**From:** John Birch <JBirch@glanvillegroup.com>  
**Sent:** Thursday, 01 September 2022 17:05  
**To:** David Schofield; Alexandros Tsavdaris  
**Cc:** Sarah Smith; George Burgess; Delafield, James; Adrian Quigley  
**Subject:** [Ext Msg] RE: 05/2022/0927 Land South Of Chiswell, Green Lane, St Albans, Hertfordshire  
**Attachments:** 8210856\_Borehole Test Locations.pdf; Falling Head Test Soakaway Results - 22-08-11.pdf; 8210856 - SK01-2 - Indicative Drainage Strategy\_220822-North\_P10.pdf; 8210856 - SK01-2 - Indicative Drainage Strategy\_220822-South\_P9.pdf

Project :  
 Land south of Chiswell Green Lane

Title:  
Indicative Surface Water  
Drainage Strategy (North Catchment)

Title: Indicative Surface Water Drainage Strategy (South Catchment)

Title :  
 Proposed Borehole Test Locations  
 Setting Out

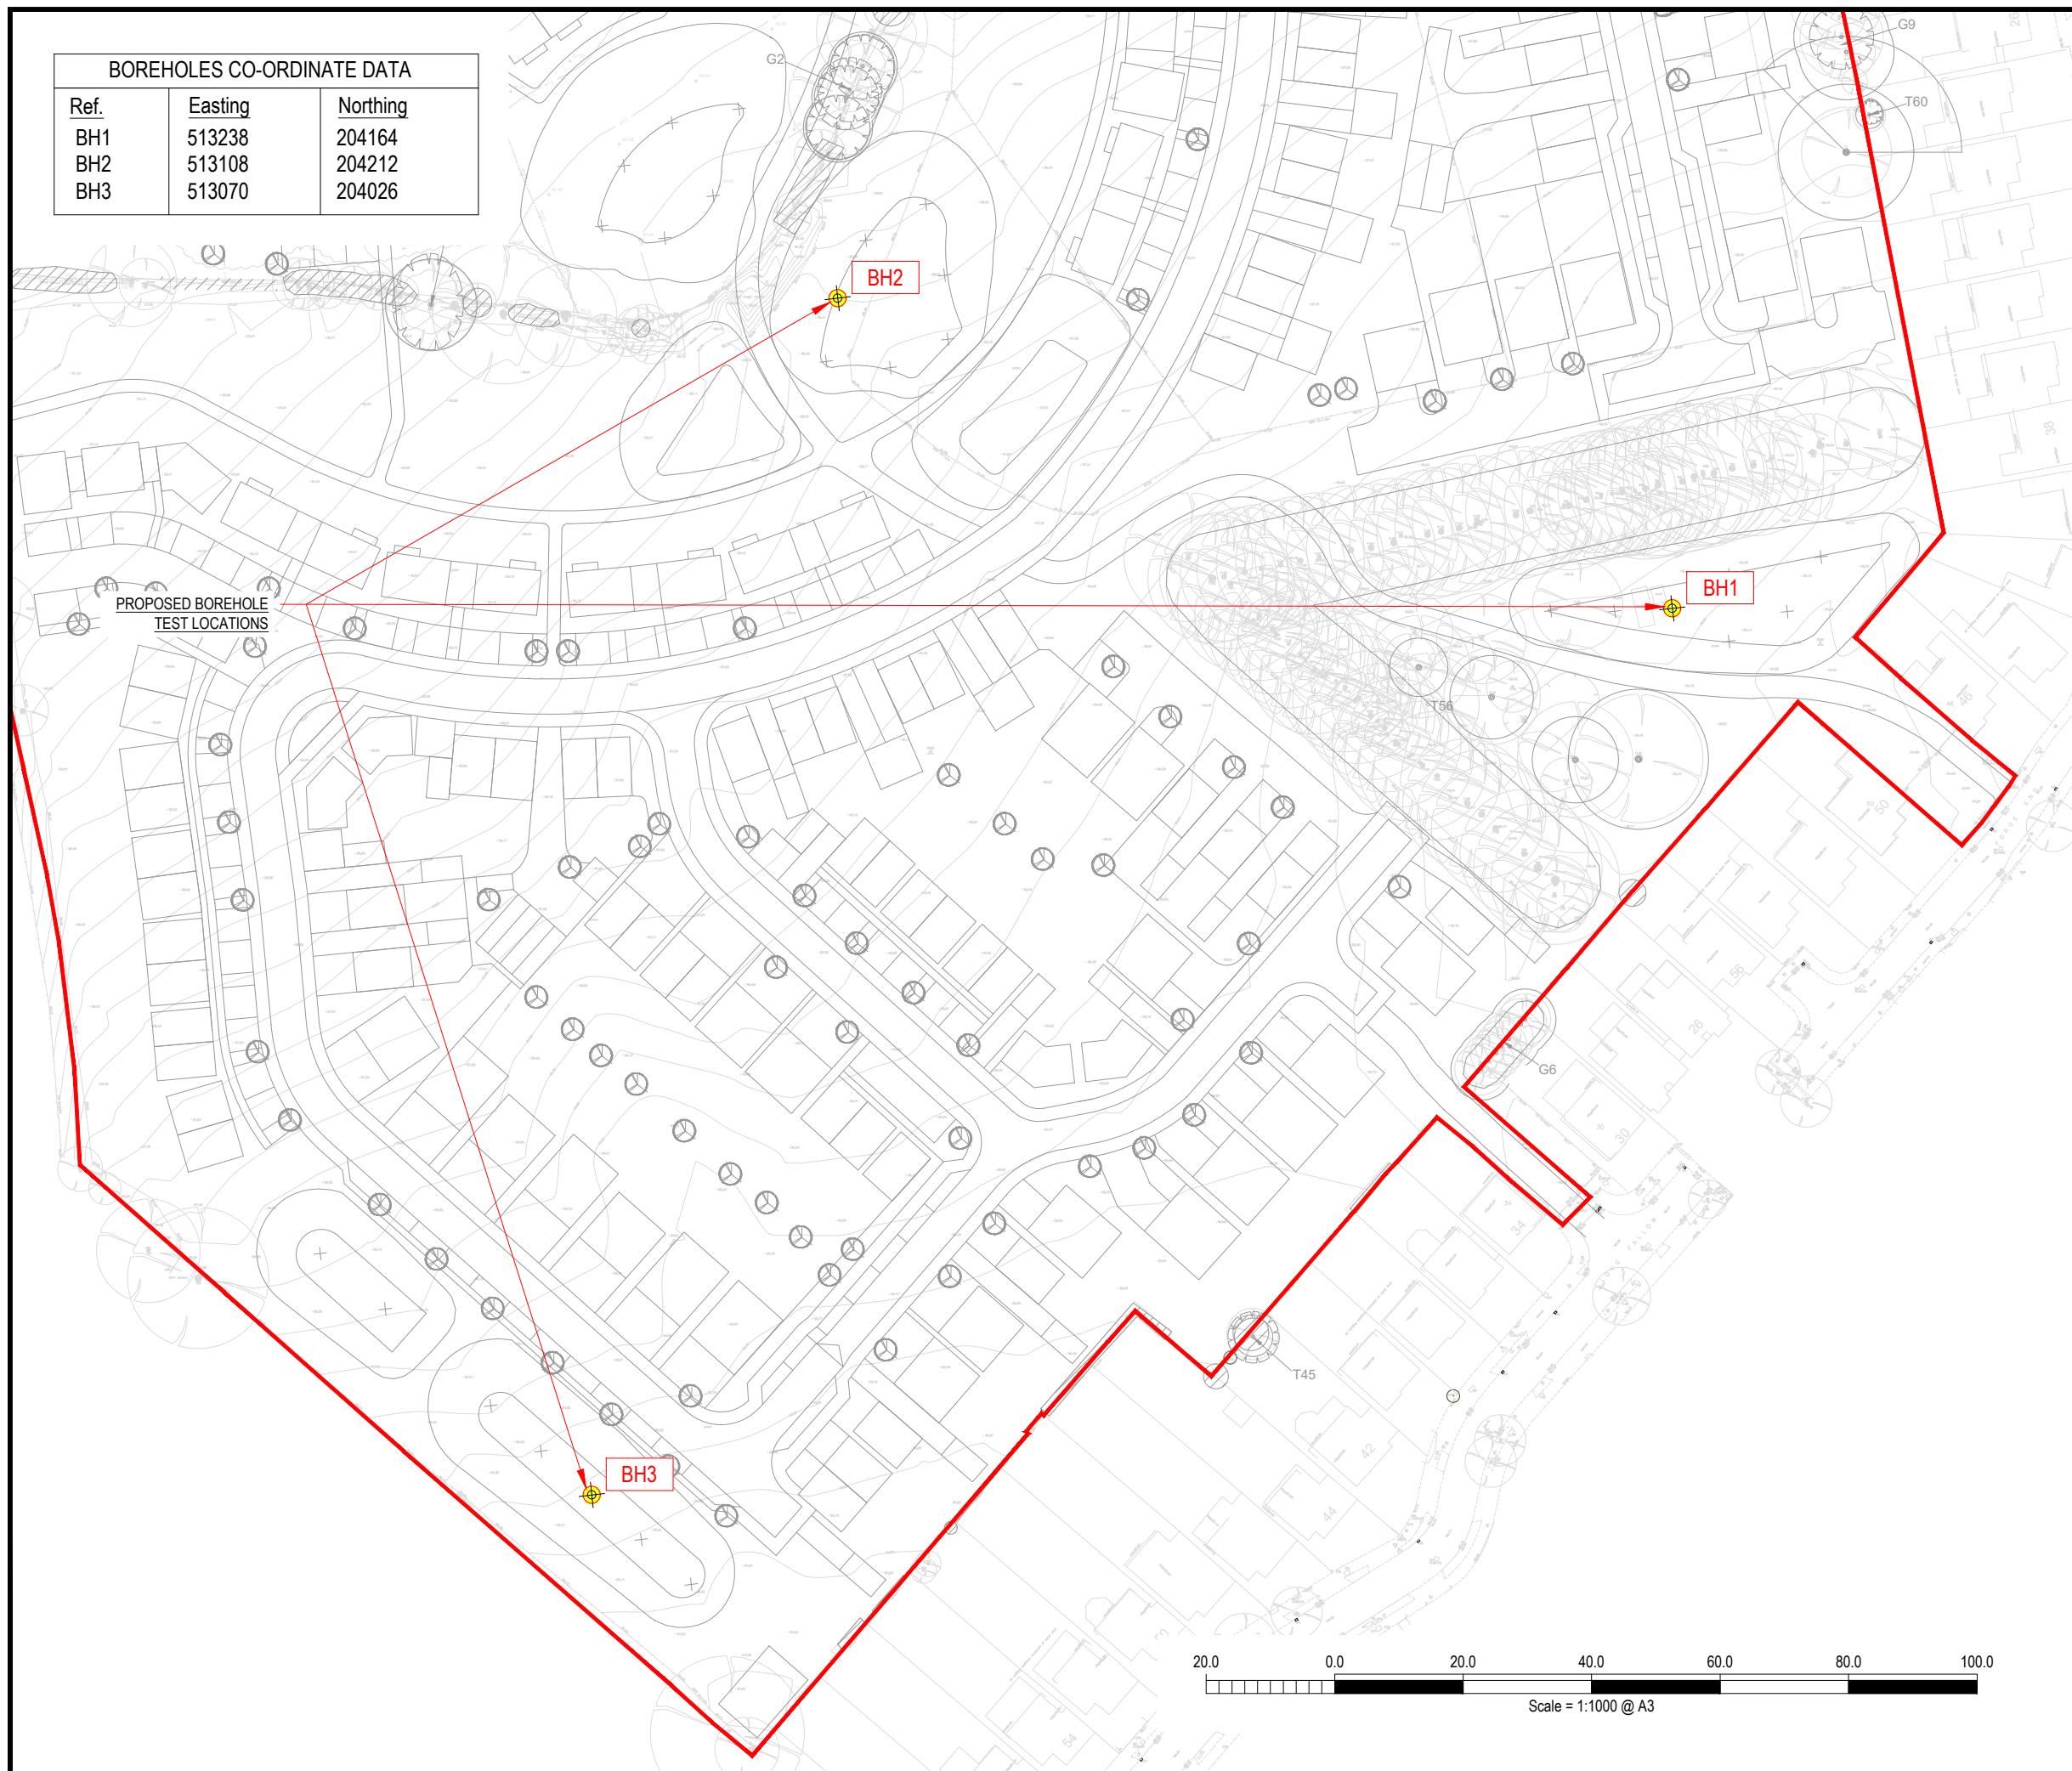
Firstly, borehole infiltration testing has been undertaken at three locations co-incident with proposed infiltration basins. The attached drawing "Borehole Test Locations" shows where the tests have been carried out. Also attached are the results of the falling head tests undertaken at each location. As expected, these have yielded very good results with infiltration rates of between 1 and  $7 \times 10^{-4}$  m/s. The infiltration basins have been sized on a assumed infiltration rate of  $1 \times 10^{-4}$  m/s at the lower end of this range. Assuming this rate, a 300mm diameter borehole taken 10m down into the chalk would achieve a discharge rate of 1.0l/s per borehole. As such, the recent infiltration testing validates the assumptions that have informed our surface water drainage strategy.

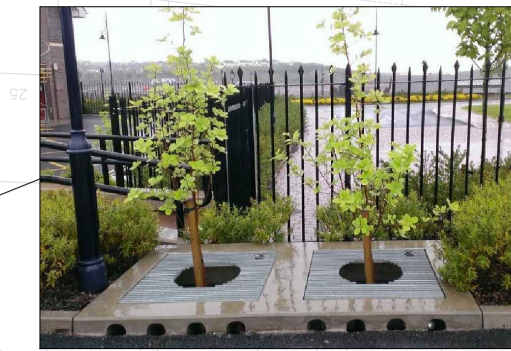
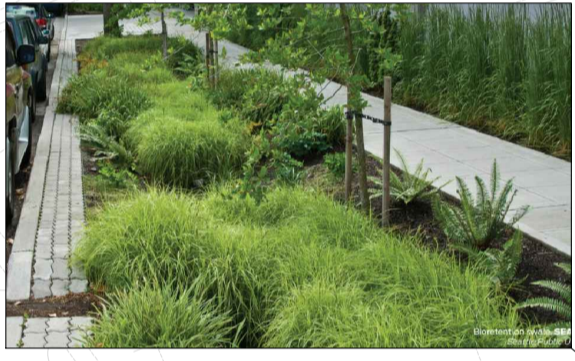
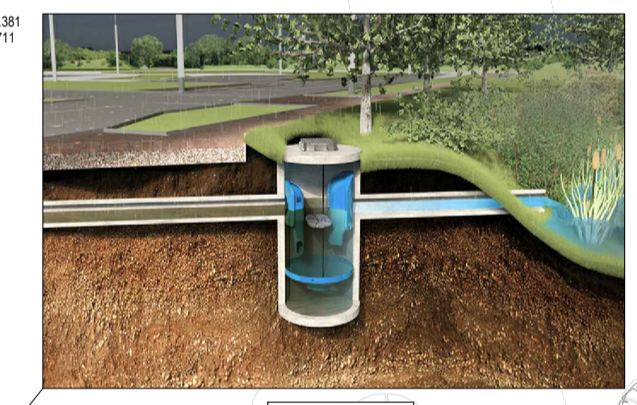
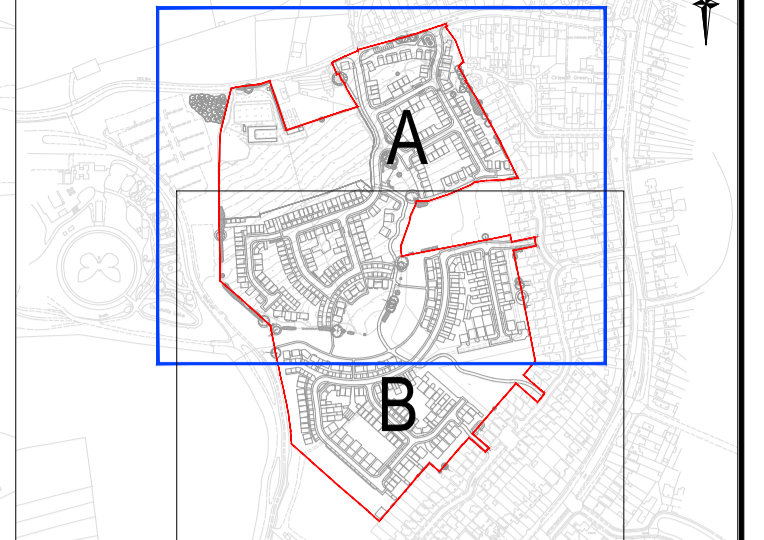
Secondly, we have amended the drainage strategy drawings as attached to provide a more robust treatment train to provide greater protection against pollution by adding Hydro-International's Downstream Defender product (or similar) upstream of every outfall to an infiltration basin – shown as purple manholes on the drawing.

P10	Updated in accordance with the comments from LPA	22/08/2022	AQ	JB
-----	--	------------	----	----

- Tree pits and swales will be established along the proposed major access roads as primary surface water treatment stage. Run-off from the proposed shared surfaces streets and private drives will be treated via permeable pavement as primary treatment stage. Hydro-International's Downstream Defender units, or similar, will be established at the immediate upstream side of each attenuation / infiltration basin to provide additional water treatment.

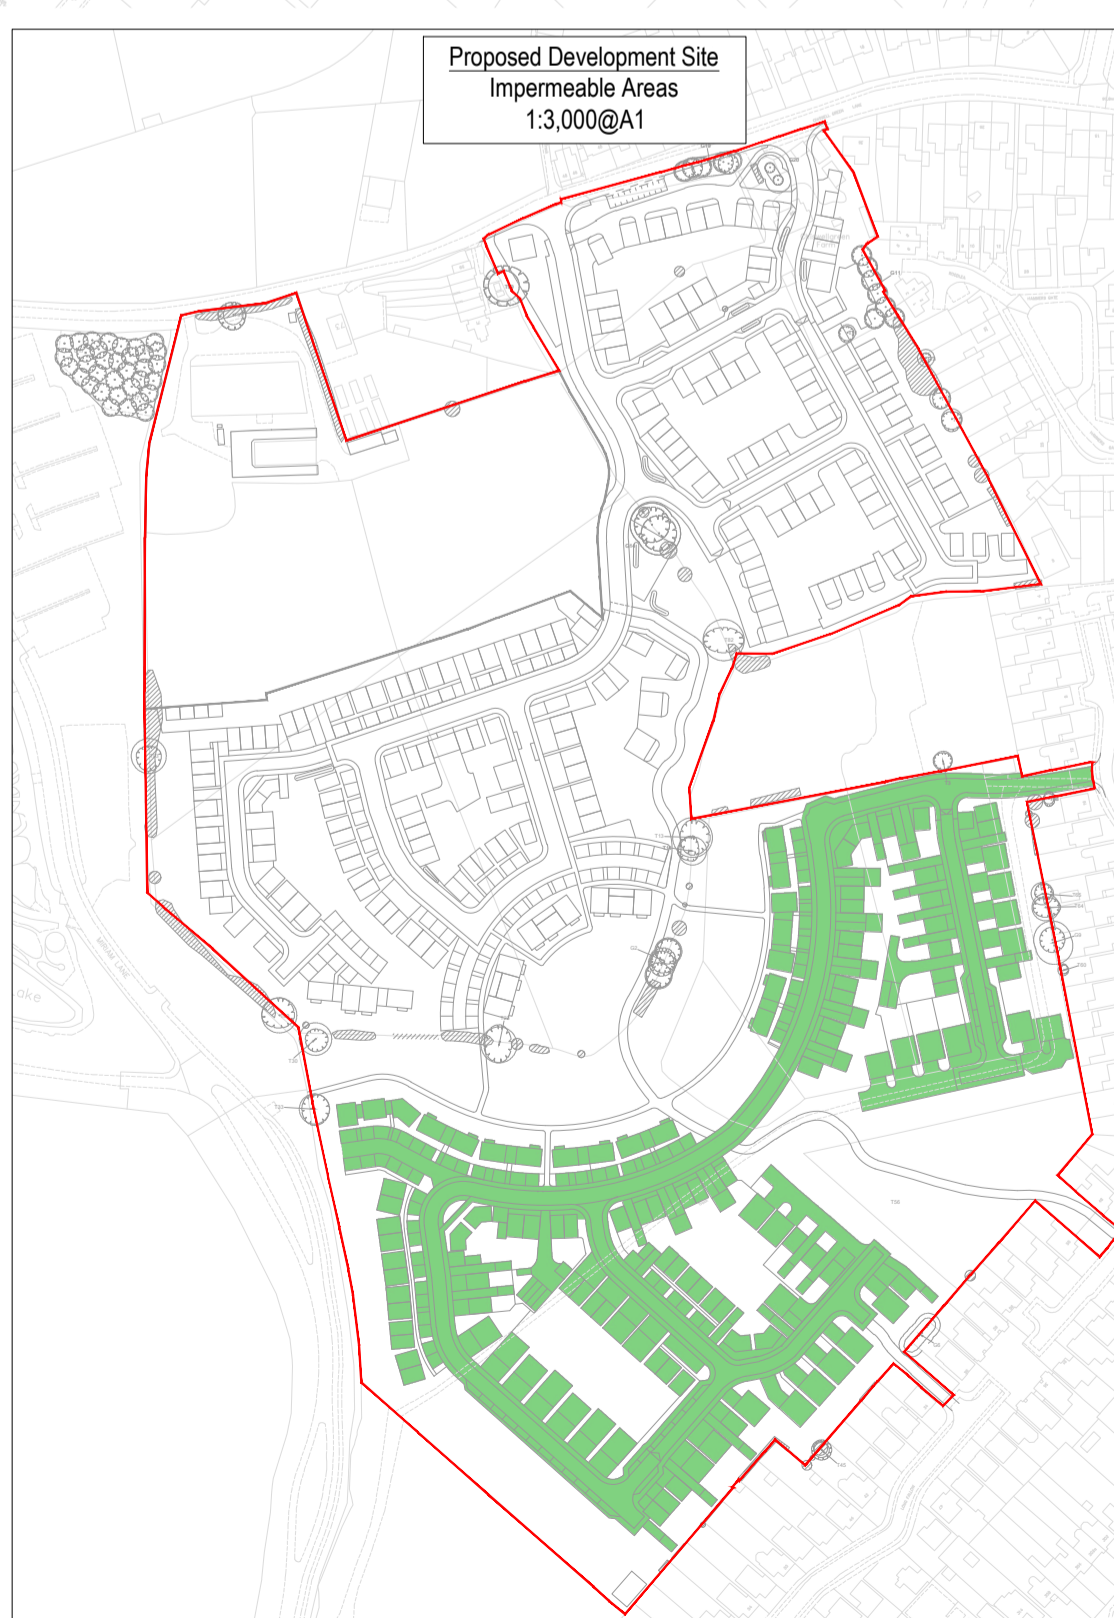
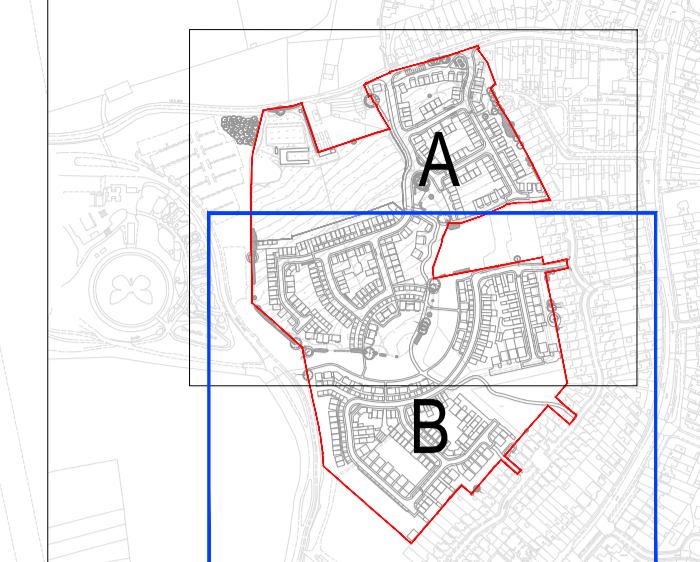
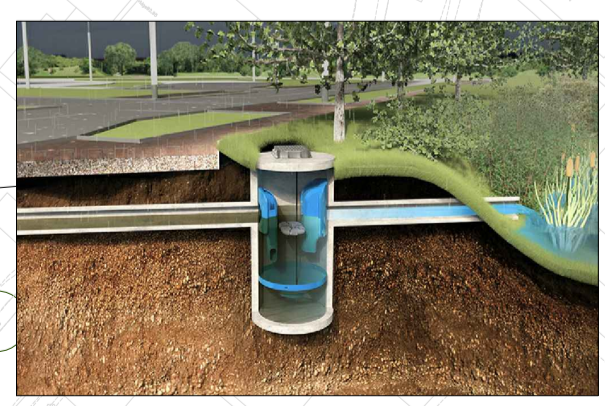
P9	Updated in accordance with the comments from LPA	22/08/2022	JB
Rev.	Description	Date	Chkd

- Tree pits and swales will be established along the proposed major access roads as primary surface water treatment stage. Run-off from the proposed shared surfaces streets and private drives will be treated via permeable pavement as primary treatment stage. Hydro-International's Downstream Defender units, or similar, will be established at the immediate upstream side of each attenuation / infiltration basin to provide additional water treatment.
